**City of Bellevue
Department of Planning & Community Development
Land Use Division Staff Report**

Proposal Name: Trinity Short Plat

File Number: 07 123485-LN

ATTACHMENT D: PROPOSED REVISED SETBACKS

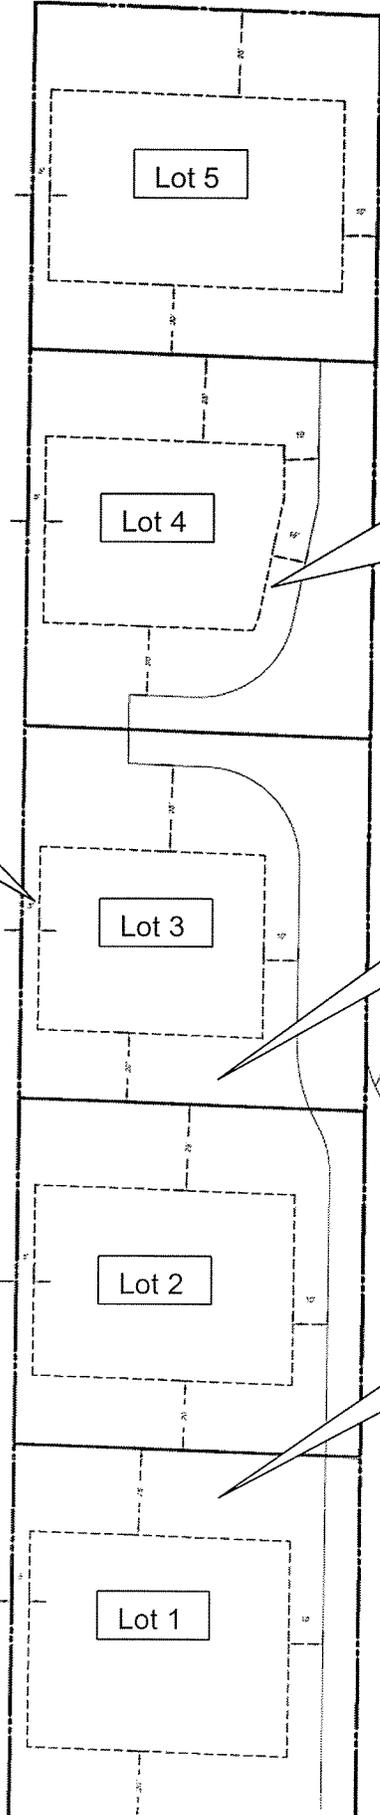
Revise all drawings for any future submittals including plat engineering/clear and grade permits (GE and UE permits), to reflect the following:

- a) Any required setback shall be shown the full width of the setback from the edge of the private access road.
- b) The front setbacks for all five proposed lots shall be along the southern property line for each lot and the rear setbacks shall be along the northern property line for each lot.

Minimum 10 foot **side** setback from property line or private road along the eastern side of proposal property and each new lot

5 foot **side** setbacks along the western property line of proposal site and each new lot

20 foot **front** setbacks along southern property lines of each new lot

25 foot **rear** setbacks along northern property lines of each new lot
